EnerTech Global, LLC 2506 S. Elm Street Greenville, IL 62246 <a href="http://www.enertechgeo.com">www.enertechgeo.com</a>	<b>TECHNICAL BULLETIN</b>	<b>DOC. #:</b>	QMS-TSF-001
	<b>Carlo Gavazzi: Field Installed Soft Start Kits</b>	<b>TEMPLATE REV DATE:</b>	05/19/2016
		<b>TB #:</b>	TB17.003
		<b>PUBLISH DATE:</b>	11/16/2017

**Carlo Gavazzi: Field Installed Soft Start Kits**

RSBS SOFT START WIRING

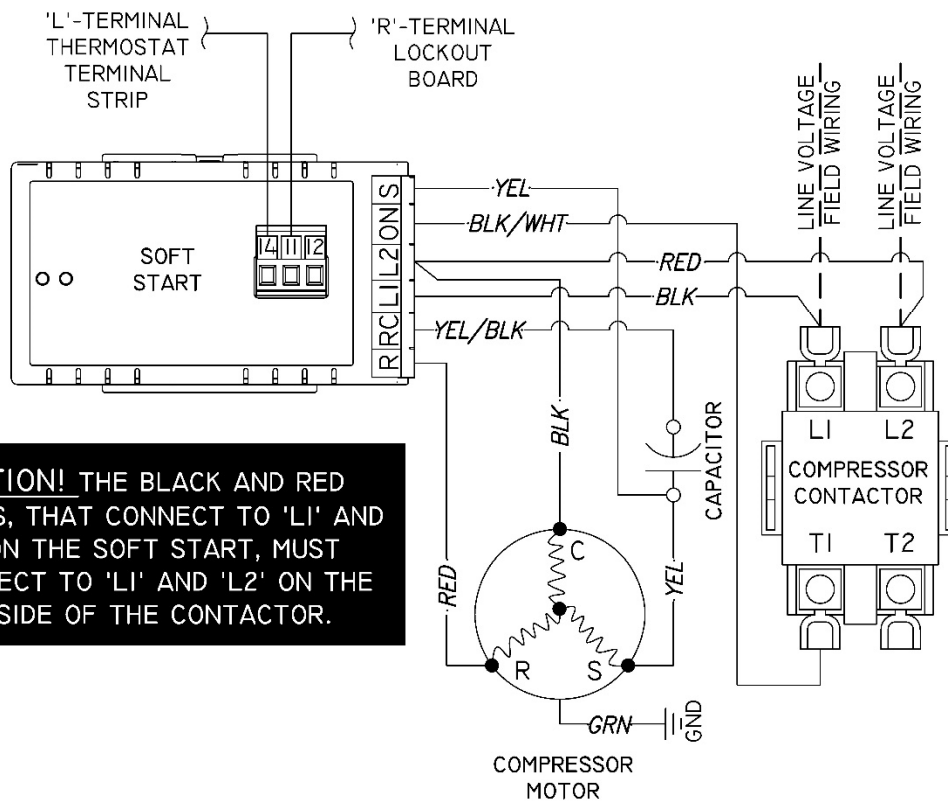
- 1. The red and black wires that connect to the 'L1' and 'L2' terminal on the soft start module MUST connect to 'L1' and 'L2' on the LINE side of the contactor.**

2. After disconnecting the red, black, and yellow wires that run from the compressor to the contactor the lugs MUST be tightened down, or a loose/ faulty connection may result.
3. The solid yellow wire, that runs from the 'S' terminal on the soft start module to the capacitor, MUST go to the same side of the capacitor as the solid yellow wire from the compressor. The yellow/black wire connects to the opposite side of the capacitor.
